UNITED STATES PATENT AND TRADEMARK OFFICE

10/768,154

Office Action Summary	Application No.	Applicant(s)	
	10/768,154	YAMAMOTO, HIDEKI	
	Examiner	Art Unit	
	Monique M. Wills	1795

DETAILED ACTION

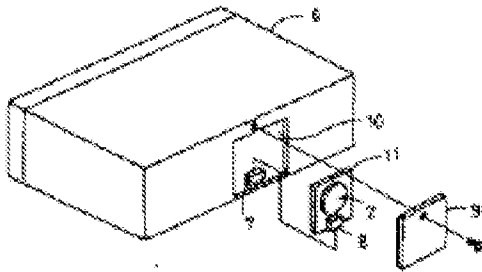
JP 4-105590 teaches a structure for mounting a backup battery, comprising a storage portion provide in a body of an apparatus and includes a recess, which opens ot the outside of the apparatus and stores the backup battery therein; and a

cover which is attached to the body of the apparatus to cover the backup battery put in the recess. A partition wall (10) separates the storage portion from the inside of the apparatus. See Figure 1.

However, JP 4-105590 does not expressly disclose a circuit board built in the apparatus, including a lead wire connection portion to the backup battery. The reference is also silent to the connection power between the circuit board and the lead wire comprising a male-female fitting connection. The reference is silent to the connection portion, insertion hole and a part of the lead wire inside an apparatus on a straight line
